STATE OF MAINE
DEPARTMENT OF TRANSPORTATION
16 STATE HOUSE STATION
AUGUSTA, MAINE
04333-0016

December 29, 2006
Subject: **Old Town**
Project No. BR-1266(100)
Pin No. 12661.00
Amendment No. 1

Old Town 12661.00 (Atlas Map 33)

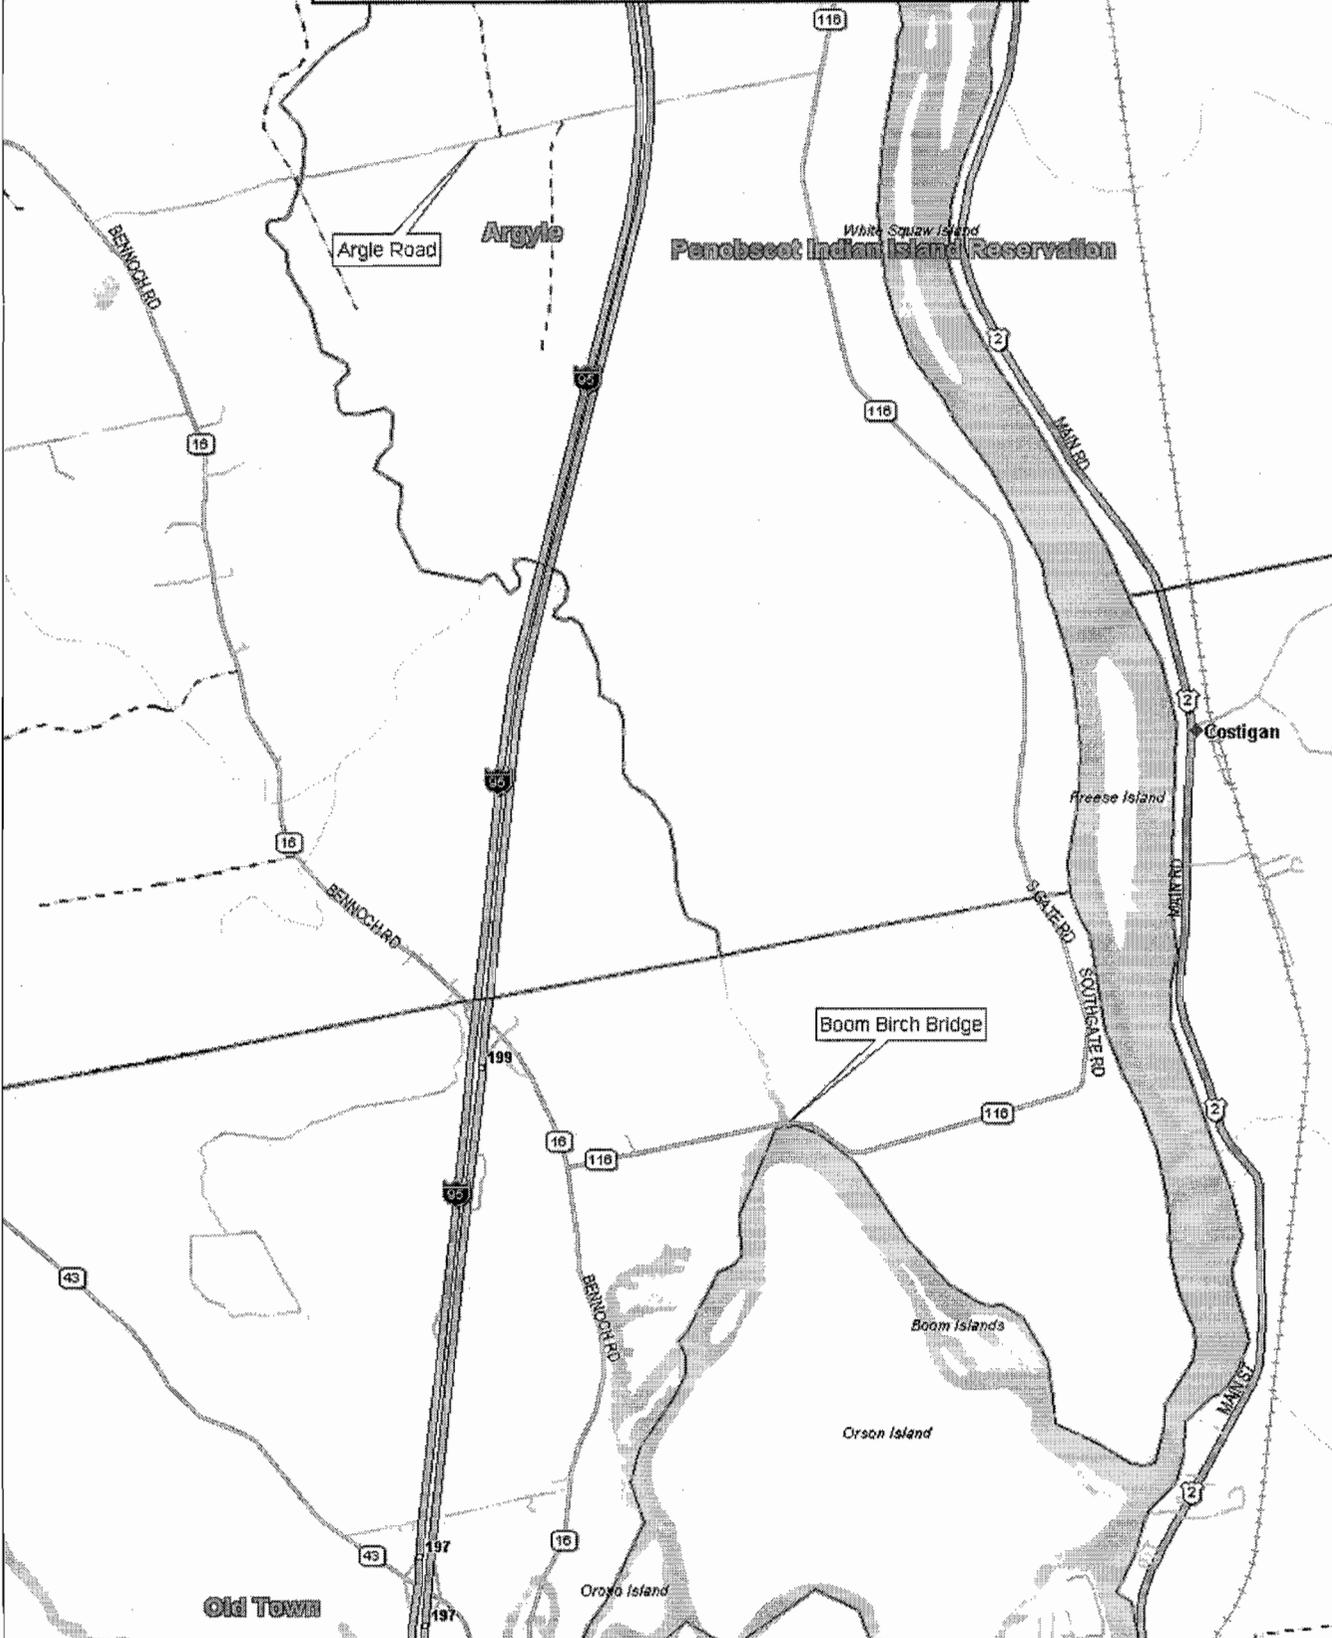
In the Book, REMOVE the existing Project Map in "Special Provision 105, Construction Area" and REPLACE with the attached new Project Map.
